Notice of Allowability

10/522,481

CHA ET AL.

FIG. 6

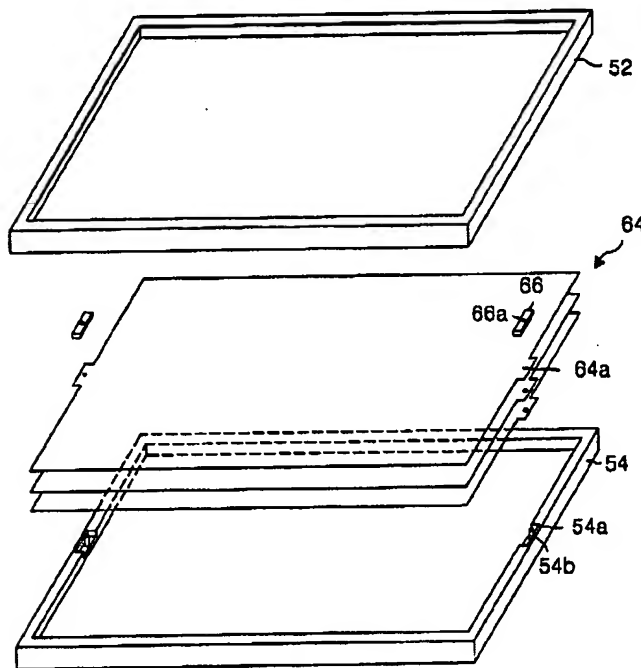
The prior art made of record and not relied upon is considered pertinent to applicant's disclosure. Kim et al (2002/0024623) teaches the use of an elastic silicon

pad (66) for preventing damage and wrinkling to optical sheets (64) caused by motion or vibration to a liquid crystal display but does not teach the elastic member (66) also being adhesive, as claimed by applicant. See paragraphs [0026], [0027] for the teaching of the elastic member (66) being secured in place by the pin (54b) through hole (66a) and by pressure of the panel guide (52)

and main frame (54). Kim et al (2002/0024623), alone or in combination with the other cited prior art, does not teach or suggest all of the limitations of the amended independent claims 1 and 9.

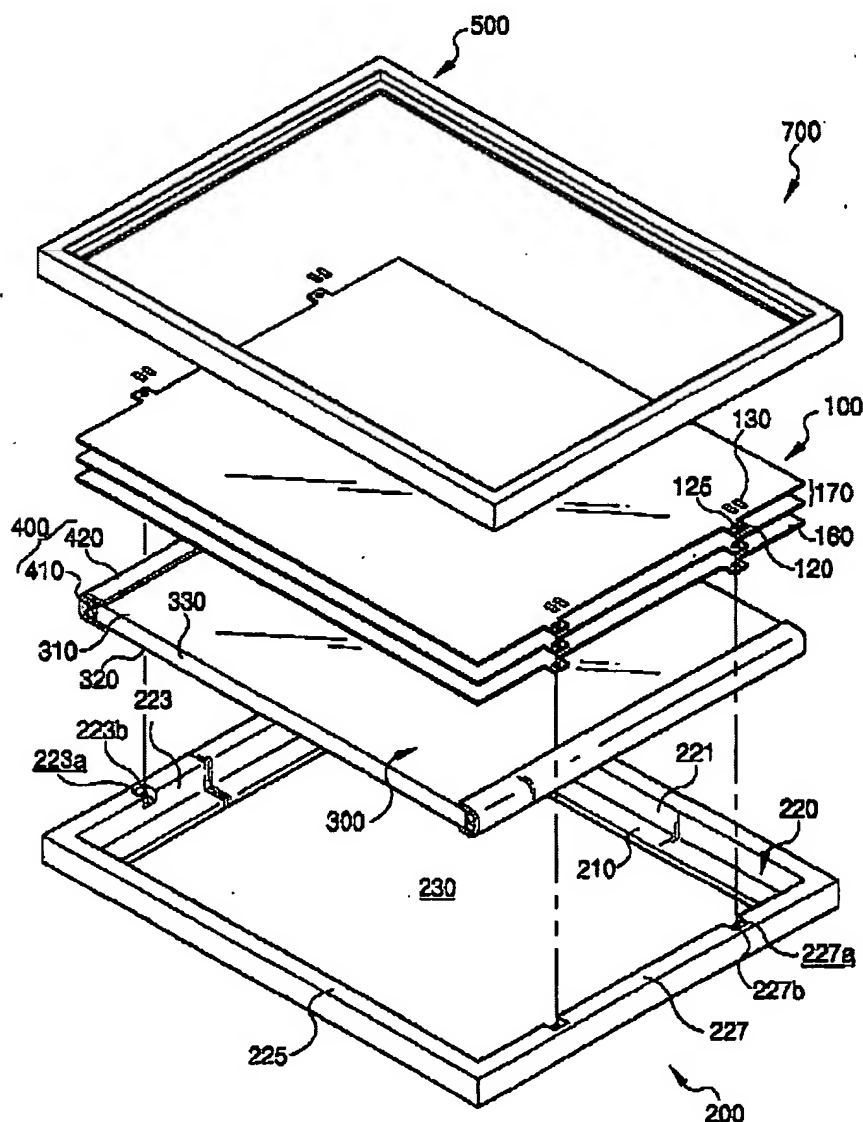
Claims 1-12 are allowed, because the cited prior art, alone or in combination, do not teach or fairly suggest a backlight assembly (700) comprising a first receiving container (200) having a bottom surface and a sidewall (223,227) extended from edge of the bottom surface (210) so as to provide a receiving space (230);

an optical module (400) including a lamp (410) for generating a first light and a first optical member (420) for generating a second light having a brightness more uniform than that of the first light;

a second optical member (100) including a body (110) for generating a third light by controlling optical characteristics of the second light and at least one fixing portion (120) protruded from edges of the body (110) toward the first receiving container (200) and coupled to the sidewall (223,227);

a second receiving container (500) combined with the sidewall (223,227) of the first receiving container (200) for covering the fixing portion (120);

and an elastic adhesive member (130) disposed between the fixing portion (120) of the second optical member (100) and the second receiving container (500), the elastic adhesive member (130) absorbing impact applied from an exterior and being expanded or contracted by a predetermined length corresponding to an expansion of the second optical member (100) to prevent a wrinkle of the second optical member (100). Further, the cited prior art do not disclose or fairly suggest a liquid crystal display panel (1000) comprising the features of the claimed backlight assembly (700) and a liquid crystal display panel (800) disposed on the second optical member (100), for changing the third light emitted from the second optical member (100) into light having image information; and a chassis (900) for fixing the liquid crystal display panel (800).
